Mindel House. Upper floors

LAYOUT REVISED TO IMPROVE LIVING SPACE
EXPOSED COLUMNS AND CAPITALS
- PICADILLY WAREHOUSE | PLANNING PRESENTATION 39

Submitted Planning proposal.
Lower Ground Floor

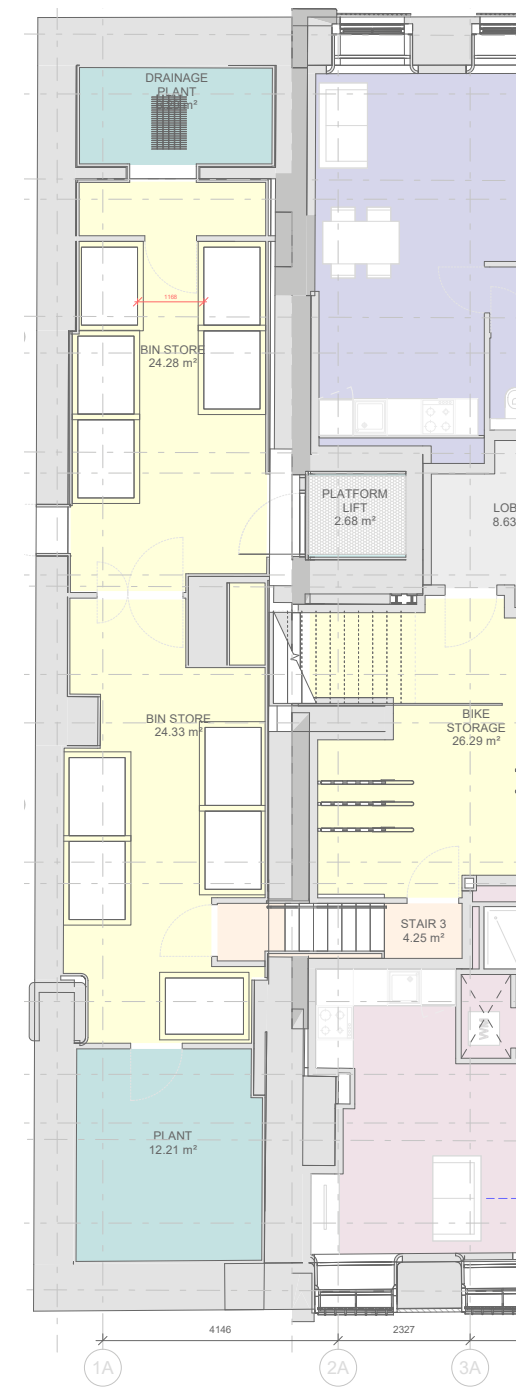
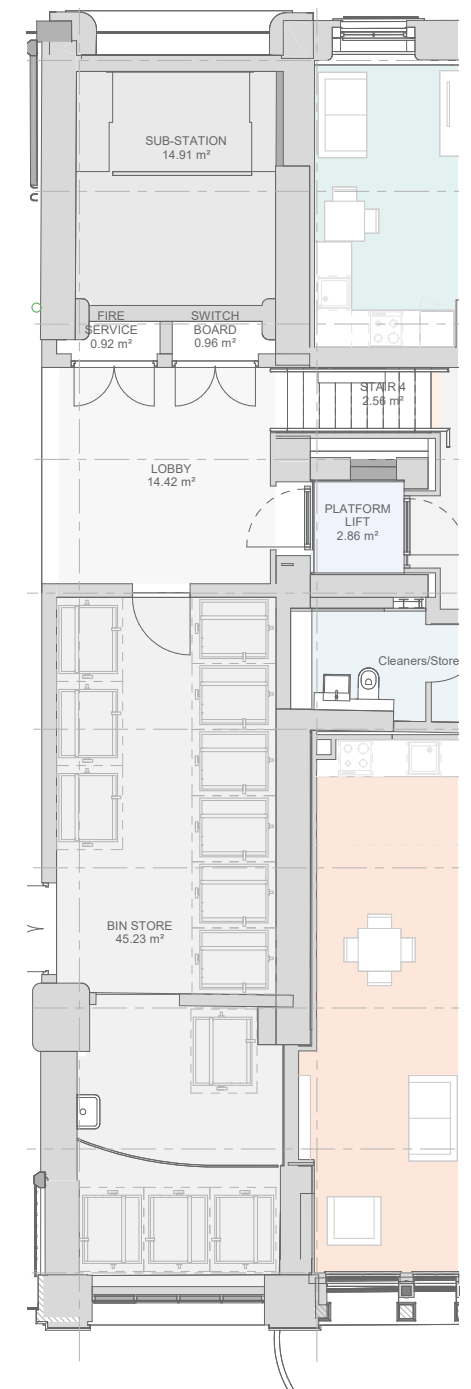
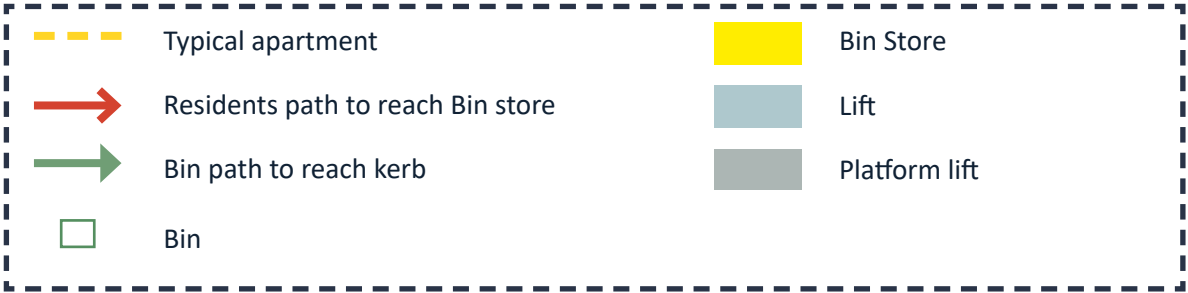
In the approved layout would only be possible to locate 10 x 1100lt bins.

There are other issues related to the approved scheme which are:

- To bring out bins for collection it is required to use the platform lift which is also the main access to the building for wheelchair users.
- Bin Store is not easily accessible by residents that need to take a lift + platform lift in order to get there .
- Bringing out bins for collection is a very long task.
- There is not enough manouvering space

The updated proposal aims at solve the above issues providing the following:

- Correct volume of bins as described in D&A weekly collection
- Bin store at street level meaning less management for collection
- Easier access for residents
- Platform lift no longer used for waste management
